TO: Fred Aguirre, Civil Engineer/Hydrology
FROM: Jim Fink, Planning & Programming Hydrologist
SUBJECT: EMBUDO HILLS CHANNEL

Re: Embudo Hills Channel - Field Visit
with Rex Funk - 12/20/83

**DESIGN REPORT
FOR
EMBUDO HILLS UPLAND DIVERSION CHANNEL**

TYPICAL CROSS SECTIONS

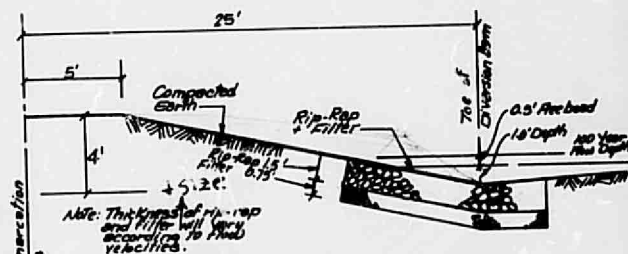
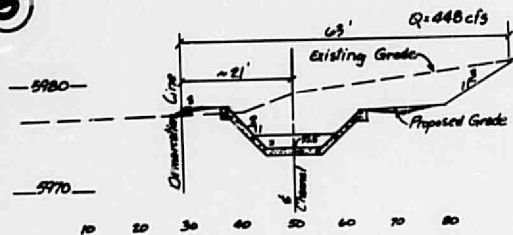
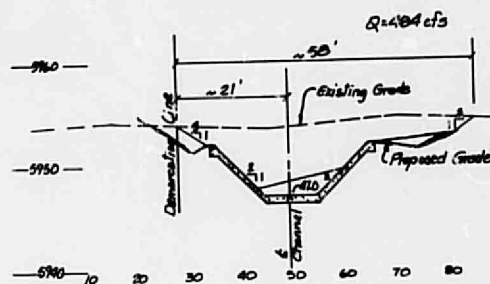
My biggest concern with the proposed diversion channel configurations that Bohannon, Huston proposed is that it is undesirable to have sheet flows entering the concrete lined channels. These flows have the potential to start paralleling the edge of the concrete section and eventually undermining the channel.
